# PATHFINDER

Ref: Source Material License No. SUA-442, Docket No. 40-6622

## **Discussion of Changes in the ACL Application.**

FIGURE 5.1-2. PREDICTED MAXIMUM CHLORIDE CONCENTRATIONS AT THE POE

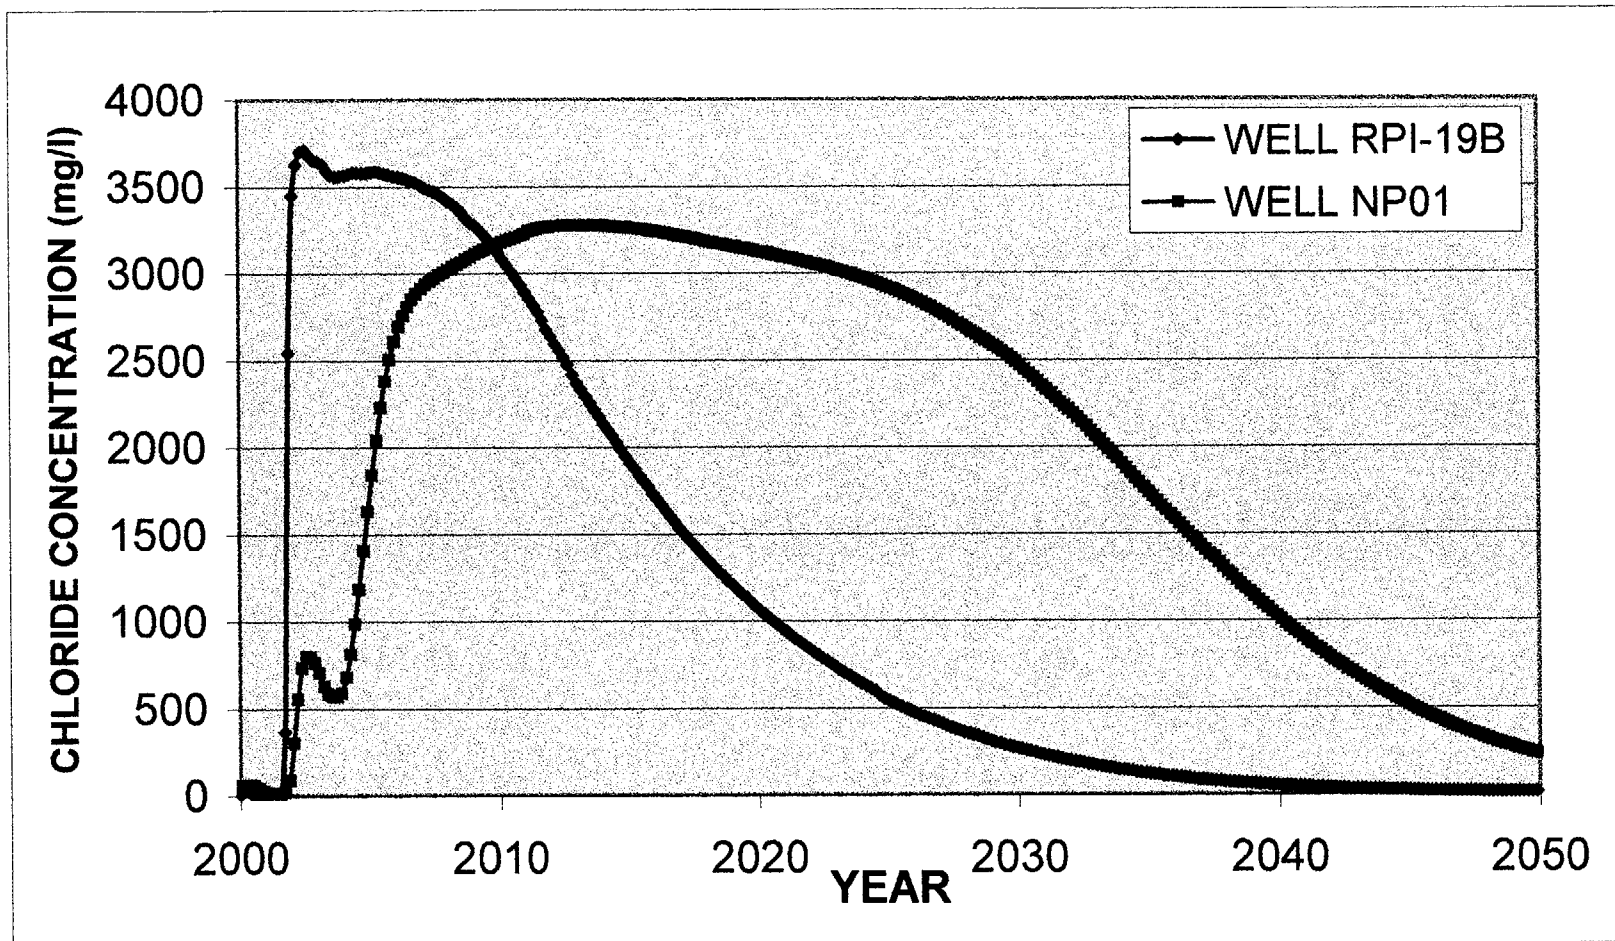
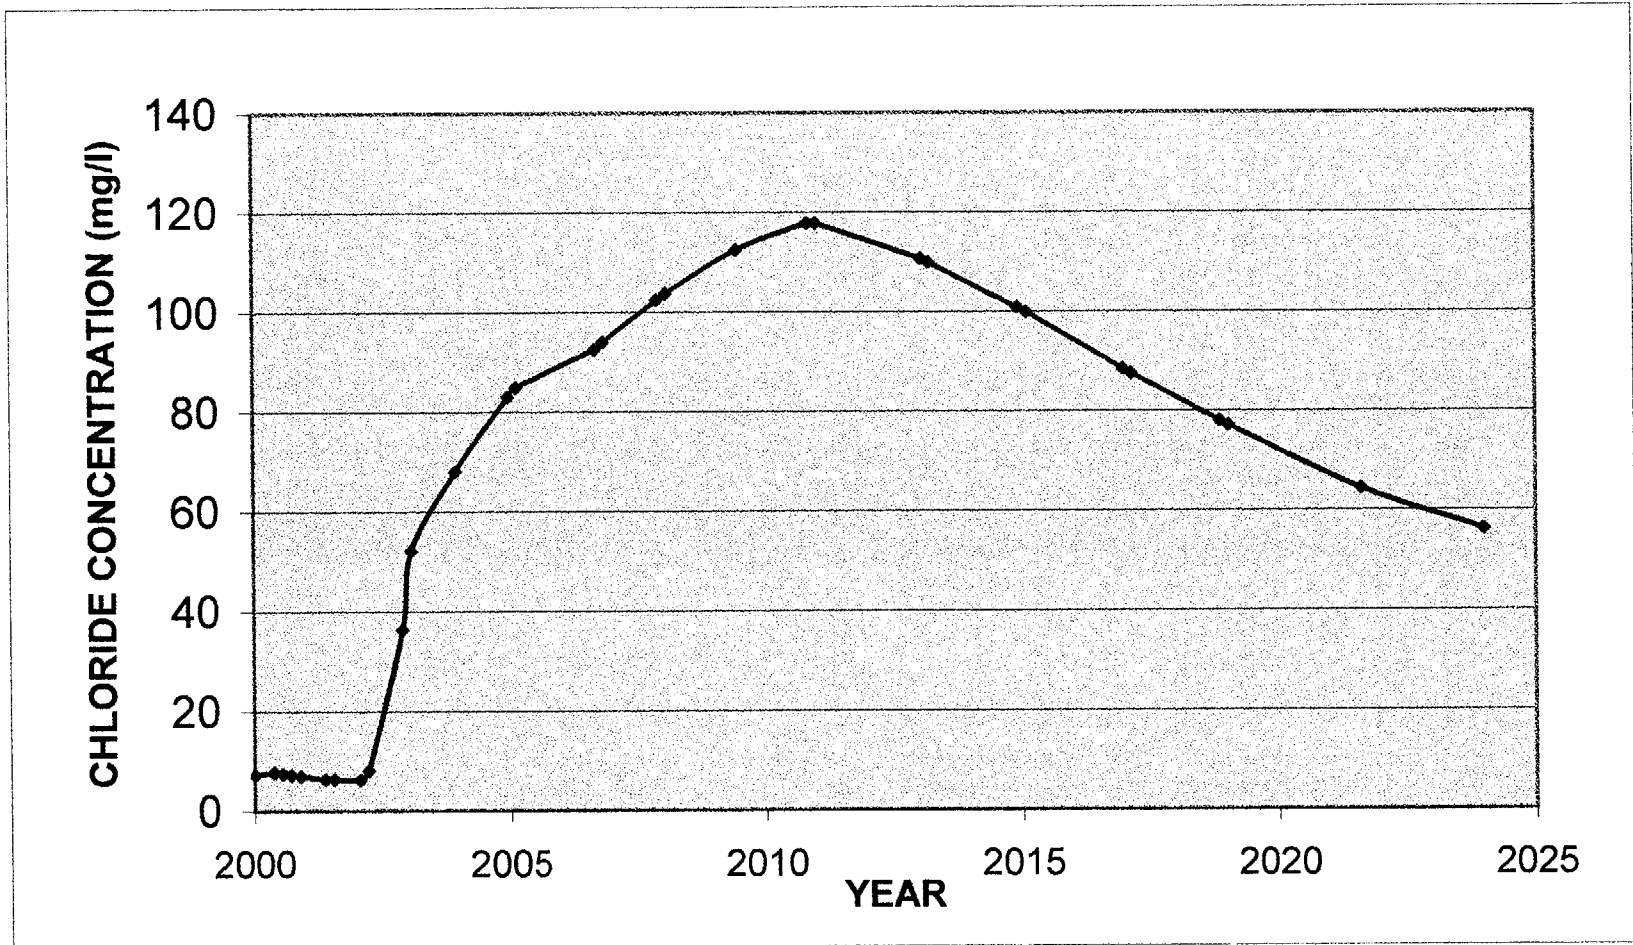
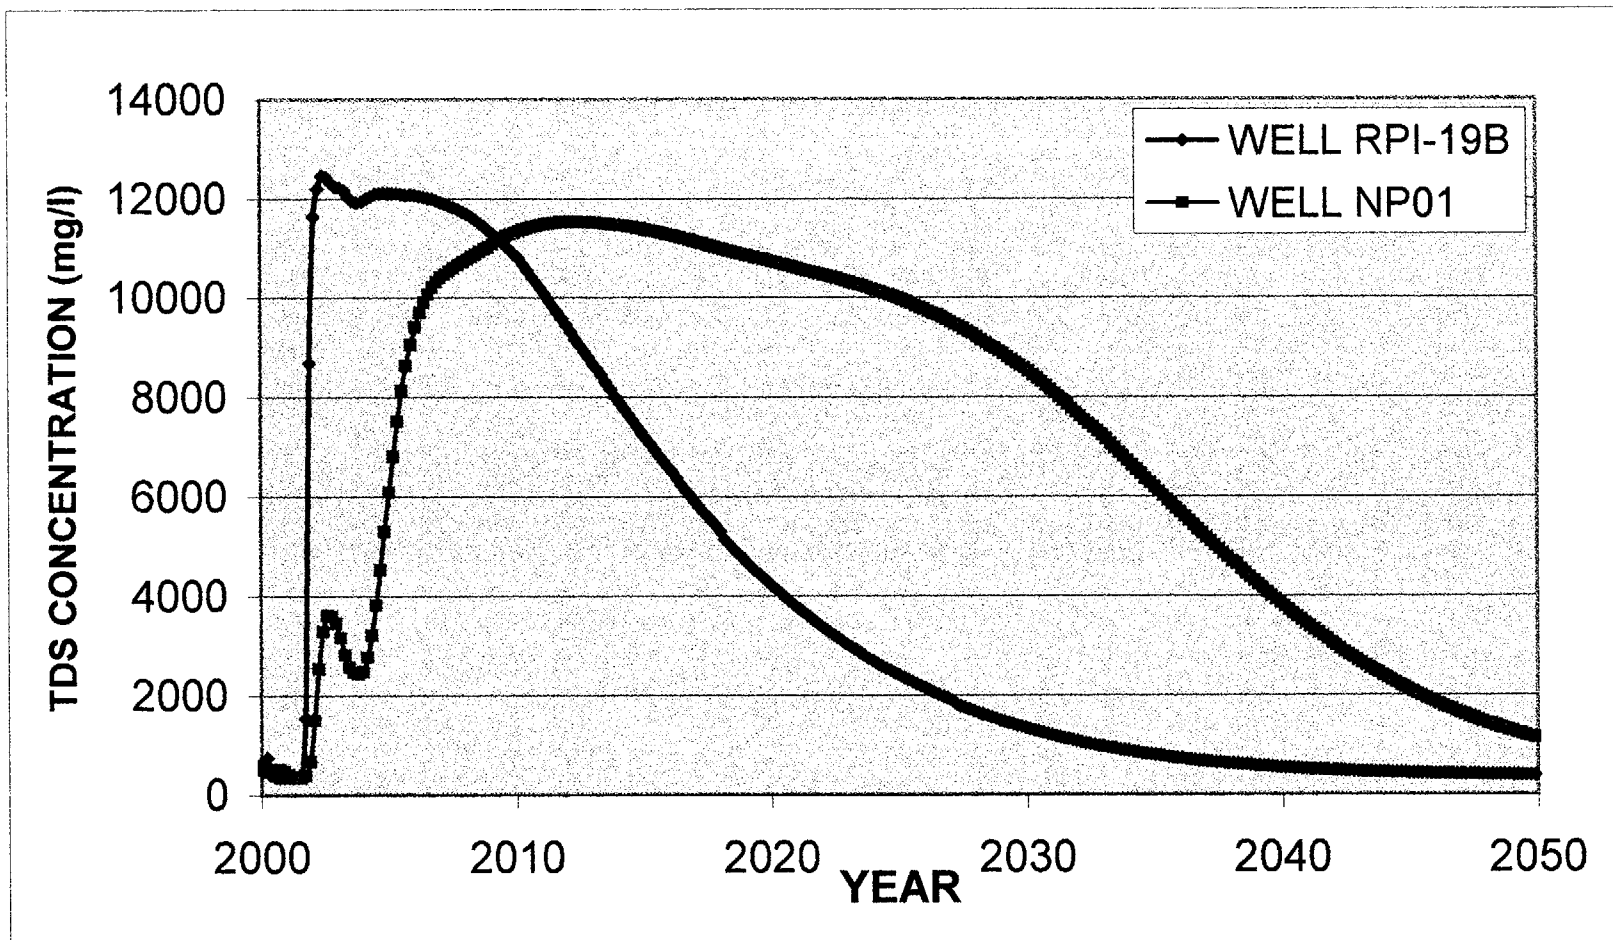
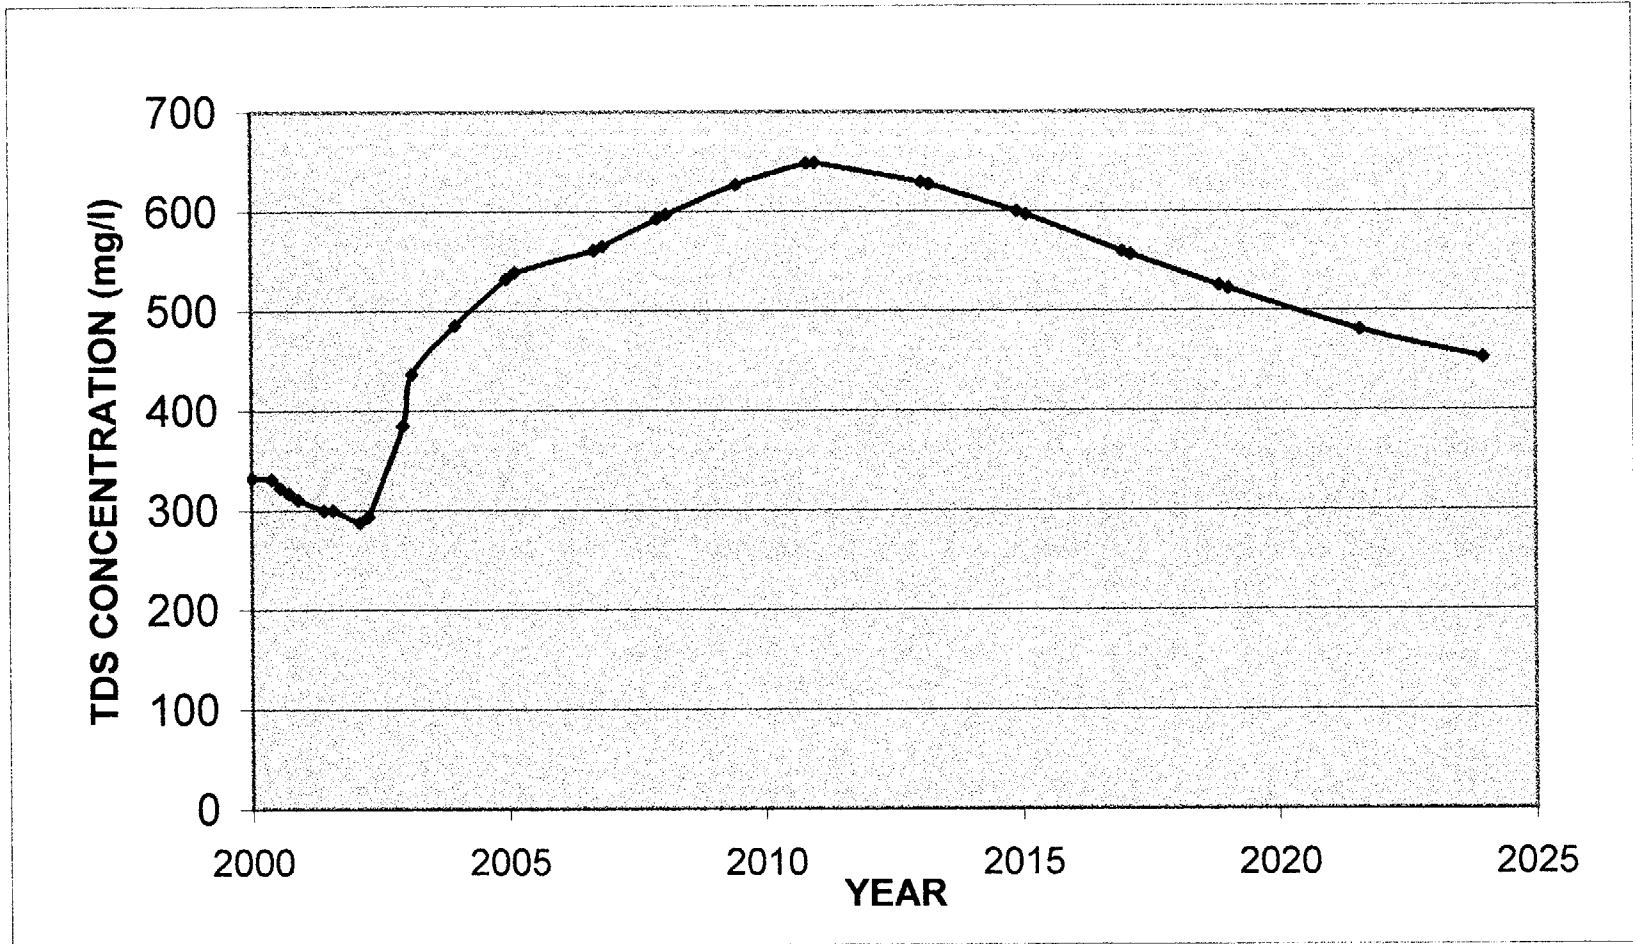
**Comment 4: NEPA constituents.**

**Discussion:** Section 5.0 has been revised/added to include modeling and analysis of these additional non-hazardous constituents. In addition, potential health and environmental concerns of these constituents is addressed in Section 2.3.2.4 and Appendices A, B and C.

Figure 5.1-1 presents the predicted chloride concentrations for POC wells NP01 and RPI-19B. The predicted peak chloride concentration at the Spring Creek POE is 118 mg/l (see Figure 5.1-2). The maximum predicted concentration at the POE is significantly below the state livestock standard of 2000 mg/l and is also well below the current drinking water standard. Table 5.1-1 presents predicted POC and POE concentrations.

Figure 5.1-3 presents the predicted TDS concentrations for POC wells NP01 and RPI-19B. The predicted peak TDS concentration at the Spring Creek POE is 649 mg/l (see
